UNITED STATES PATENT AND TRADEMARK OFFICE

Office Action Summary

09/857,204

KELSO ET AL.

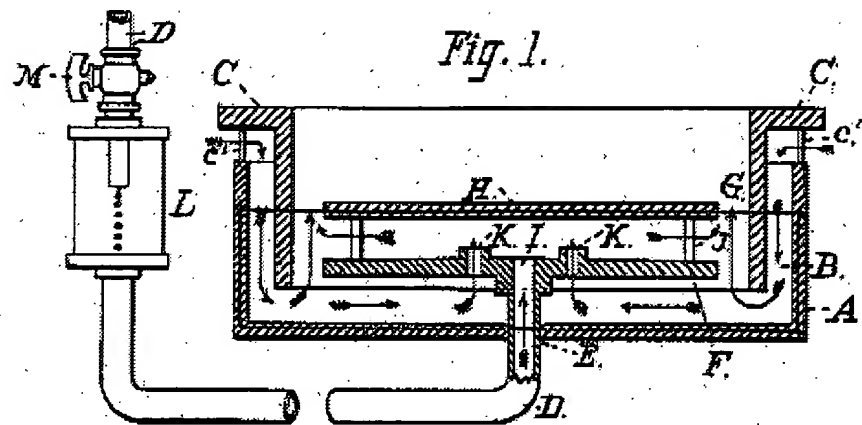
11. Regarding rejections based upon the reference Patterson ('068), applicant apparently desires that only the space between plates "H" and "F" of the reference be considered a chamber. While the examiner agrees that the space defined by these plates is a chamber, a device is not limited to having a single chamber. Chambers may be within other chambers. A chamber may be divided into plural sub-chambers. It is noted that the instant specification contemplates a divider being in the "chamber" (see page 7, lines 8 and 9 and claim 21). Therefore, the space including that between plate "H" and the bottom wall of "A" (having hole "E" through which "D" extends) may also be properly considered a chamber, even though it may also be considered divided into one or more sub-chambers such as the space between "H" and "F". An example of what may be considered a chamber of Patterson ('068) in accordance with the rejection of claim 1, is illustrated below:

It is clear that considering that which is mark in red above to be a "chamber" is completely consistent with the usage of the word "chamber" in the instant specification. Compare the above to, for example, instant Figs. 4 and 9(a)-(c). Applicant states "if the Official Action is asserting that the 'chamber' is define by F,G and H"; however, as illustrated above, "G" is a divider within what is considered "the chamber". As explained in this and the previous office action, the mixed fluid outlet is considered to be between "H" and "G". This is consistent with the intended use depicted by Patterson ('068) using arrows in Fig. 1 of the reference.
